## 27629 HAGGERTY ROAD – HEFCO JSP24-22

Public Hearing at the request of Hefco Haggerty LLC for Preliminary Site Plan, Woodland Permit, and Stormwater Management Plan approval to build a speculative (SPEC) building. The subject parcel is zoned OST, Office Service and Technology and is located south of Twelve Mile Road, on the west side of Haggerty Road. The applicant is proposing to construct a 37,925 square foot building on 9.47 acres of land with wetland mitigation proposed at the rear of the property by the Sheetz development that is proposed at the corner of Twelve Mile and Haggerty Road.

# PLAN REVIEW CENTER REPORT

Revised Preliminary Site Plan

PROJECT: GRADING & DRAINAGE PLAN  
 SHEET NO. 7  
 DATE: 05/18/2024  
 J09 NO. 22-455  
 SCALE: 1" = 30'  
 CHECKED BY:  
 DRAWN BY: DH  
 DESIGNED BY: ST  
 CITY REVIEW COMMENTS: 1/17/2024  
 CIVIL REVIEW COMMENTS: 1/17/2024  
 CITY REVIEW COMMENTS: 1/17/2024

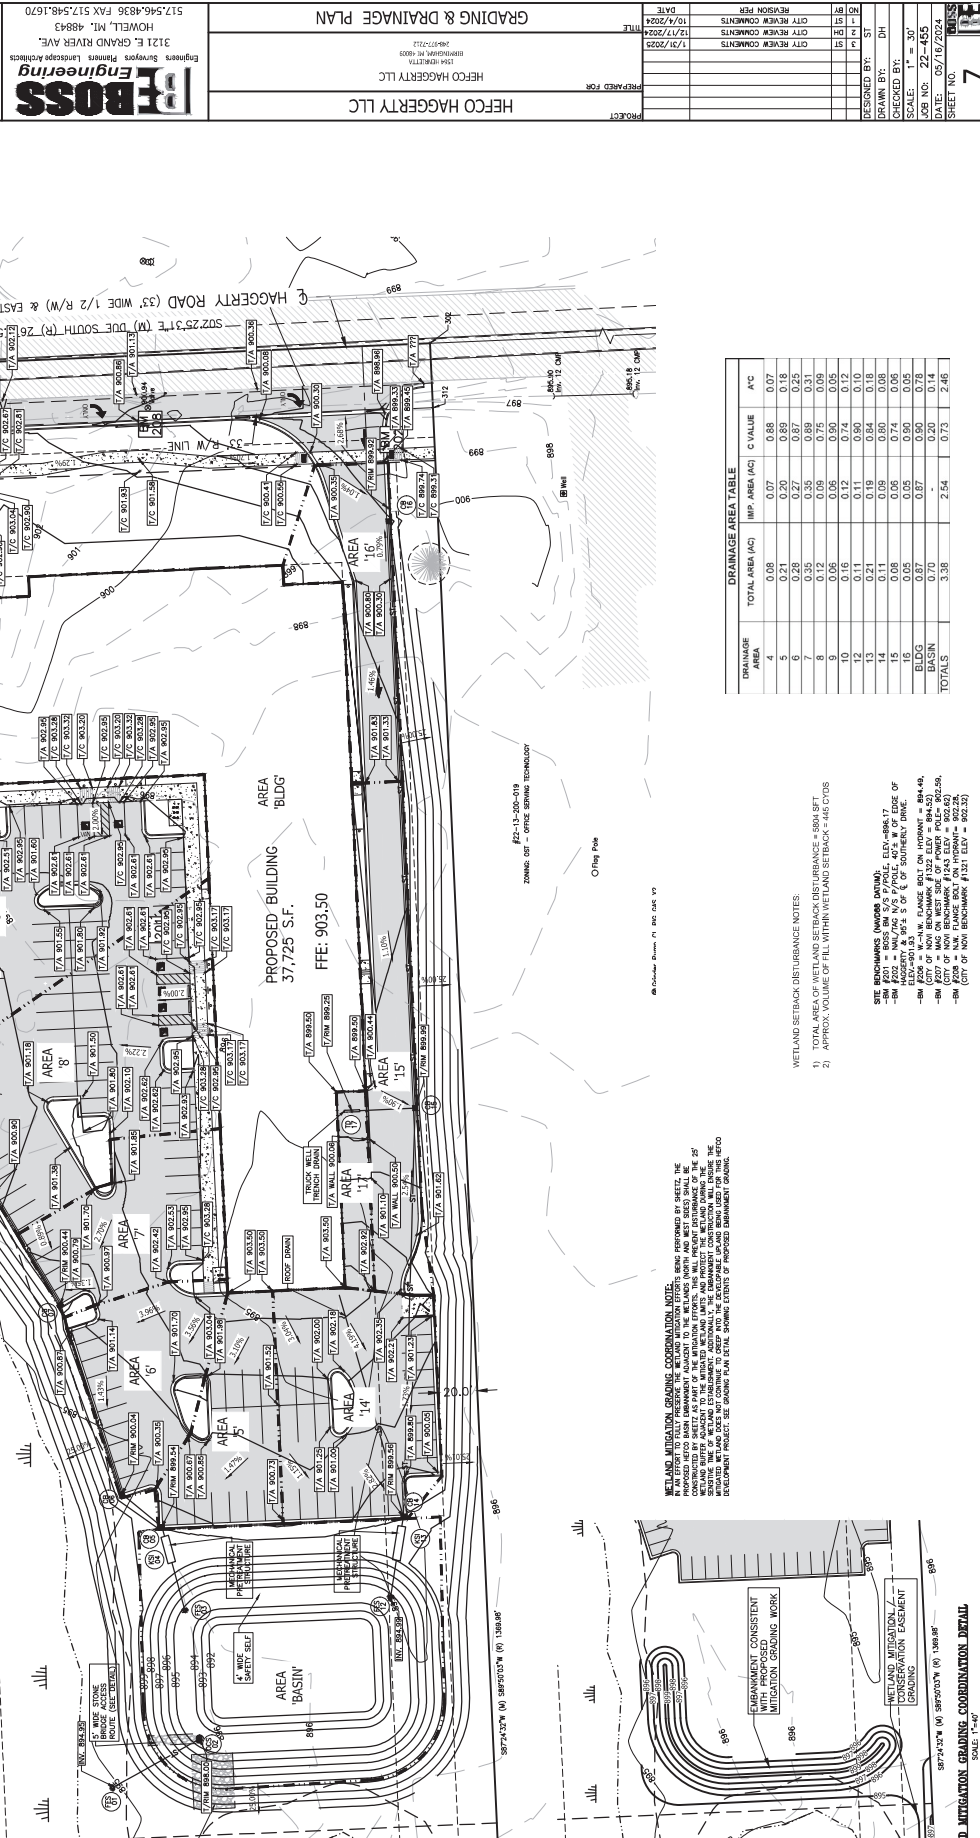
62. The drainage area table on the Grading & Drainage Plan sheet lists areas 4 to 16, but the plan view shows areas CB-5 to TD-17. Please revise this sheet to be consistent between the plan view drainage areas and those listed in the table.

62. The Drainage Area Labels in plan view have been updated to be consistent with the Drainage Area Table on the Grading & Drainage Plan (Sheet 7).

DESIGNED BY: TC  
 CHECKED BY: TC  
 SCALE: 1" = 50'  
 JOB NO: 22-455  
 DATE: 05/19/2024  
 SHEET NO: 11

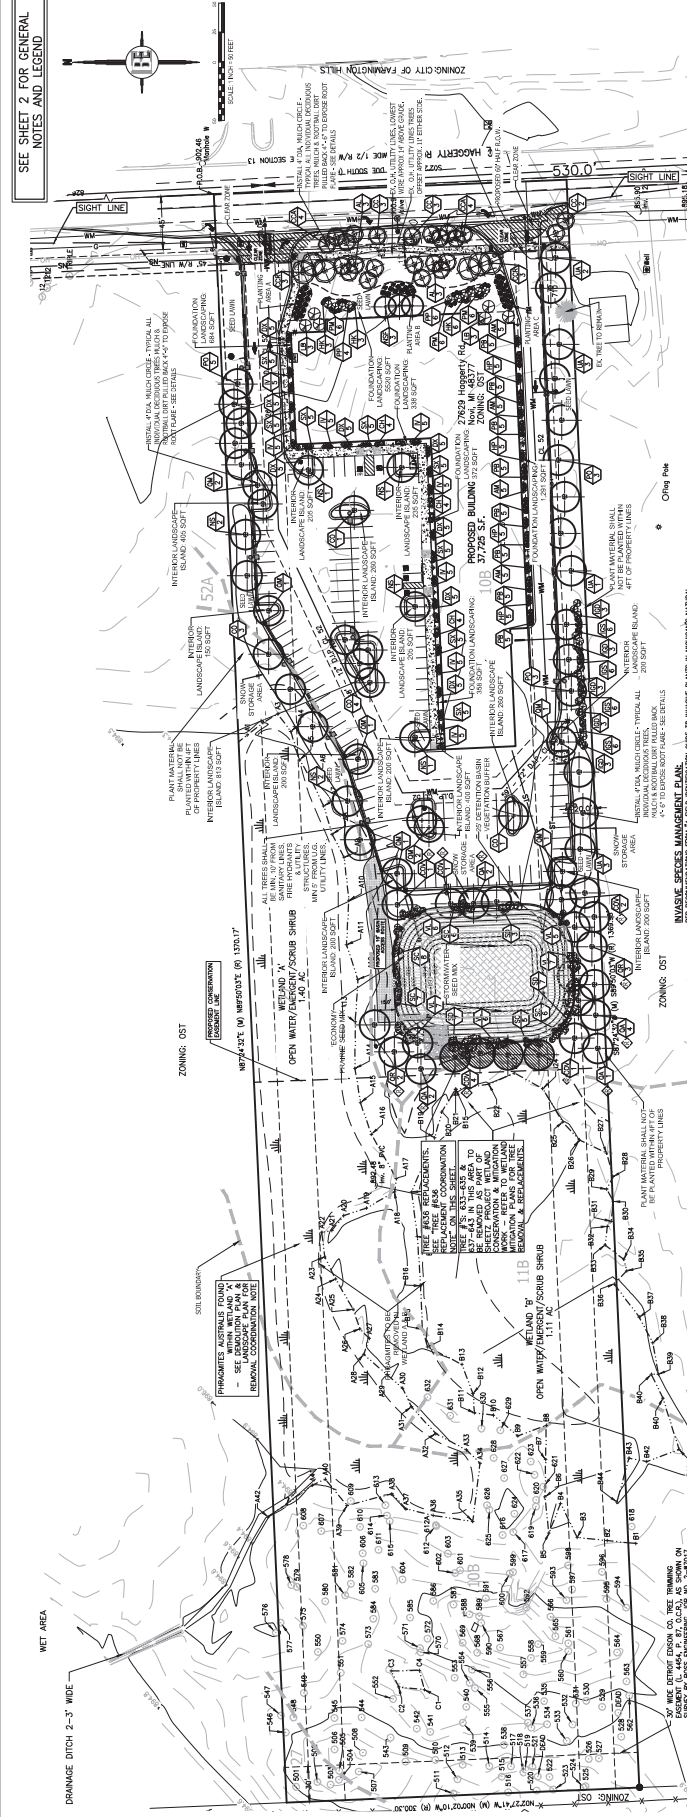
It should be noted that the applicant states on Sheet 11 that 23 replacement trees are required. Most of the trees that are proposed to be removed are not regulated woodland trees and only Trees 635-637 are required to be replaced under Chapter 37.

**Plantings around Fire Hydrant:** Note regarding distance from utility lines and structures added to the Supplemental Landscape Notes on Sheet 11.

**Screening of outdoor storage, loading/unloading:** A note regarding maintaining the hedge at least 6-ft and including in the property master deed has been added to the Supplemental Landscape Notes (Note 10) on Sheet 11 and cross-referenced on the landscape plan itself.

**Irrigation Plan:** Landscape irrigation plan will be provided as part of the final site plan package and so noted in the Supplemental Landscape Notes (Note #8) on Sheet 11.

SK-05

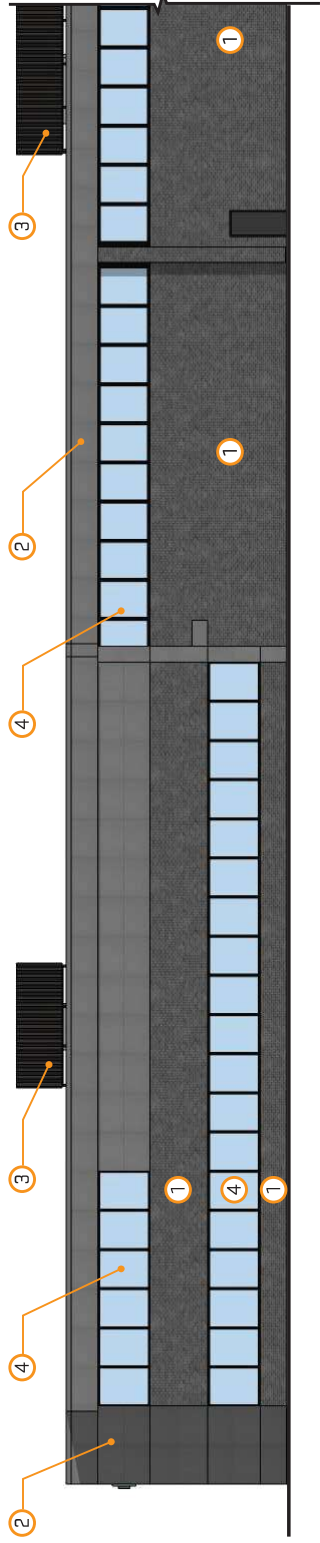
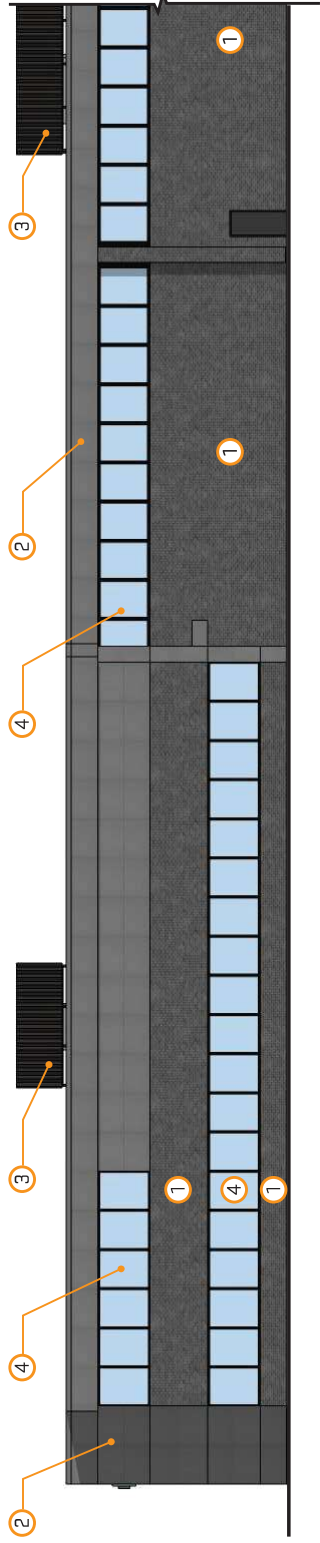
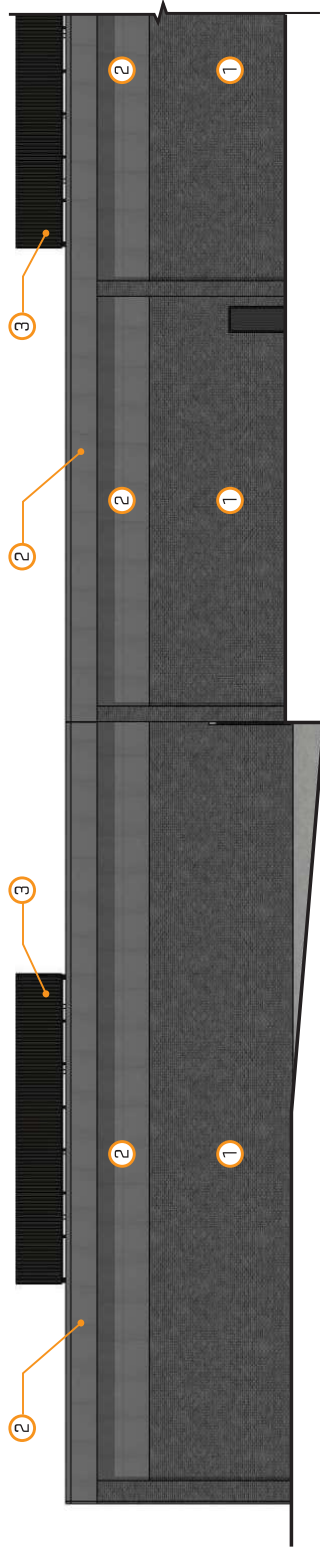
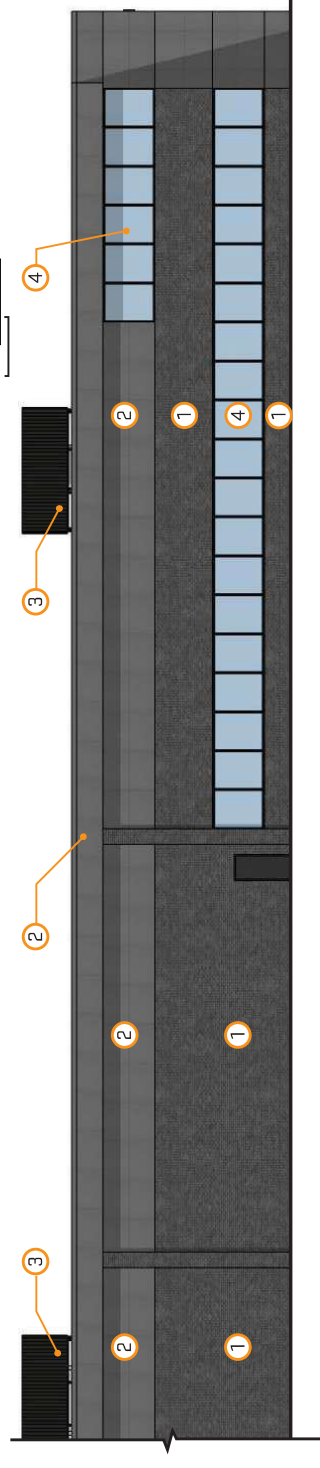
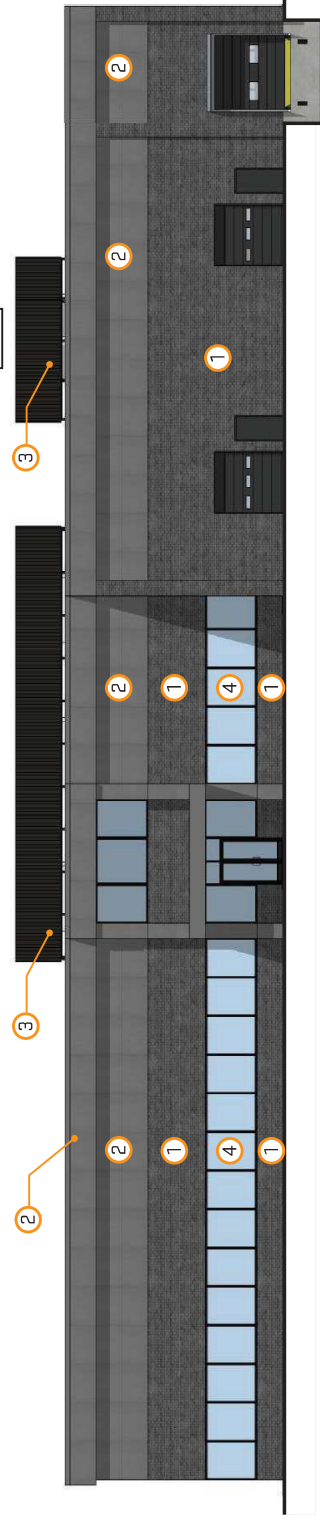
8. Building Height (Sec. 3.1.23 D & SEC. 3.20.1): Maximum height is 46' or 3 stories, whichever is less. *Elevation views on sheets SK-06 and SK-07 have been added with associated building height information. The height from the ground to the parapet is proposed to be 28', and 34' from the ground to the top of the mechanical rooftop screening.*

**Figure 1. City of Novi Regulated Woodlands Map**  
 Approximate Site boundary is shown in Red.  
 (Approximate) Regulated Woodland areas are shown in Green.

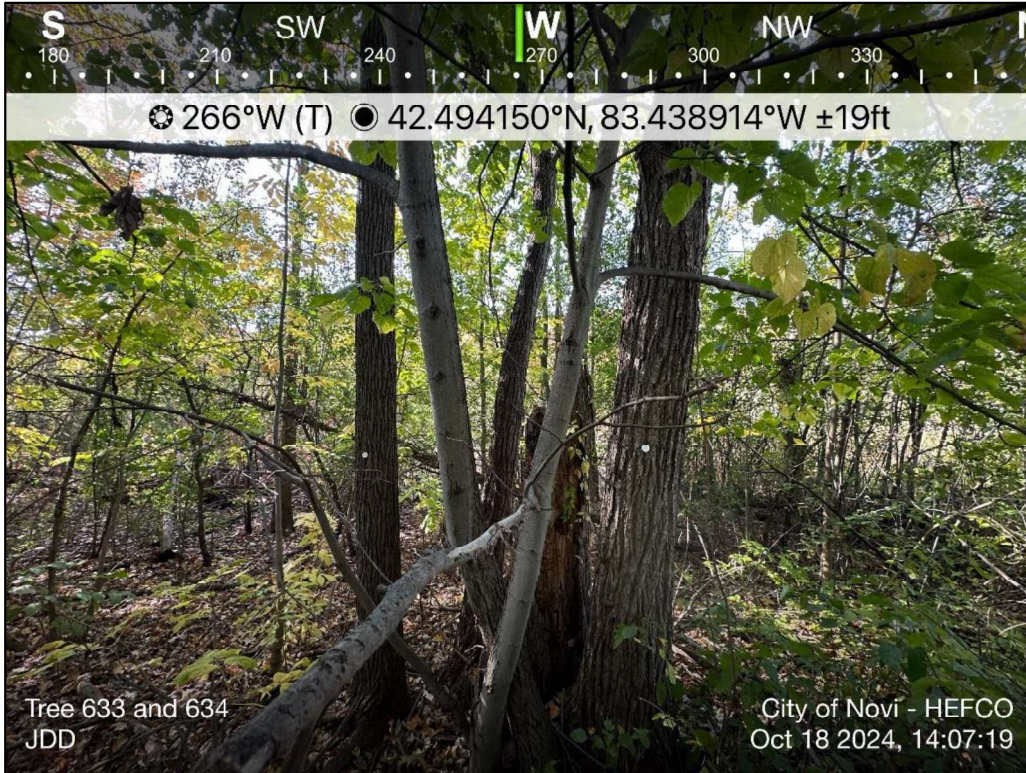
1. City-regulated woodlands, as identified on the City of Novi Woodlands interactive map website, are present onsite. Note that both the woodlands and property limits depicted on the City map are considered approximations (**Figure 1**).
2. Merjent conducted a site visit on October 18, 2024 to review the site conditions relative to the PSP submittal. Site photographs are included in **Attachment A**. The on-site conditions reflect the conditions listed in the PSP.
3. When a proposed site plan is located within a regulated woodland, any tree proposed for removal with a diameter at breast height (DBH) greater than or equal to eight inches will require tree replacement

**Figure 2. City of Novi Regulated Wetlands Map**  
 Approximate Site boundary is shown in red.  
 (Approximate) Regulated Wetland areas are shown in blue.

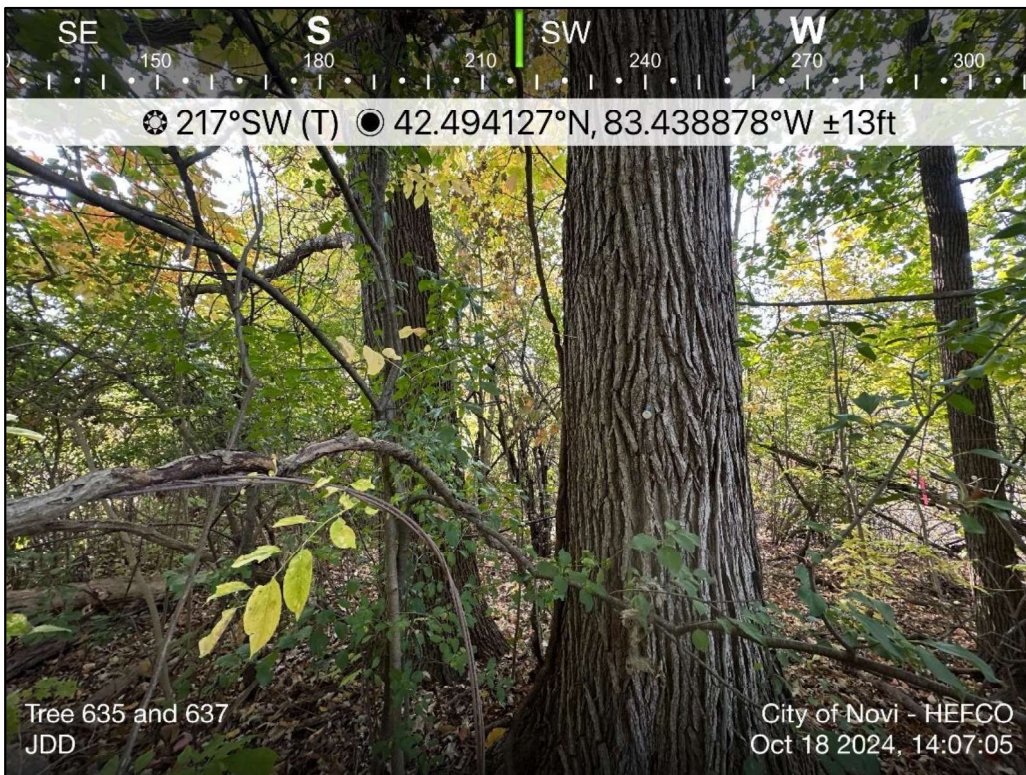
- City-regulated wetlands, as identified on the City of Novi interactive map website. Note that both wetland and property limits depicted on the City’s map are considered approximations (**Figure 2**).
- Wetlands that are regulated by the Michigan Department of Environment, Great Lakes, and Energy (EGLE).
- Wetlands as identified on National Wetland Inventory (NWI) and Michigan Resource Inventory System (MIRIS) maps, as identified on the EGLE Wetlands Viewer interactive map website (maps included in previous reviews). NWI and MIRIS wetlands are identified by the associated governmental bodies' interpretation of topographic data and aerial photographs.
- Hydric (wetland) soil as mapped by the U.S. Department of Agriculture, Natural Resource Conservation Service, as identified on the EGLE Wetlands Viewer interactive map website.
